Rezoning Transportation Analysis

Petition Number: 2024-143

General Location Identifier: 11901210, 11901207, 11901204, and 11901203

Date	Description
1/22/25	First Review (CJM)
2/19/25	Second Review (CJM)
9/24/25	Third Review (CJM)
10/23/25	Fourth Review (CJM)
12/23/25	Fifth Review (CJM)
01/22/26	Sixth Review (CJM)
2/19/26	Seventh Review (CJM)

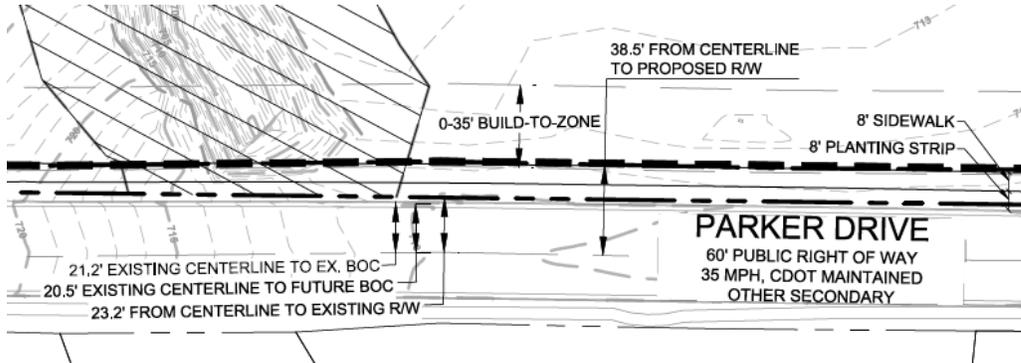
~~3. **New Comment 2.19.25:**~~

~~**Curblines:**~~

~~a. **Remount Road:** Location of future back of curb and gutter to be installed 27' from centerline.~~

~~2+ Avenue, Buffered/Separated Bike Lanes from Charlotte Streets Map~~

~~b. **Parker Drive:** Location of future back of curb and gutter to be installed 20.5' from centerline.~~

~~CLDSM U-05A1 Local Office/Commercial Wide~~

~~c. **Berryhill Road:** Location of future back of curb and gutter to be installed 20.5' from centerline.~~

~~CLDSM U-05A1 Local Office/Commercial Wide~~

~~Label and dimension the curb and gutter from the centerline for each road on the site plan.~~
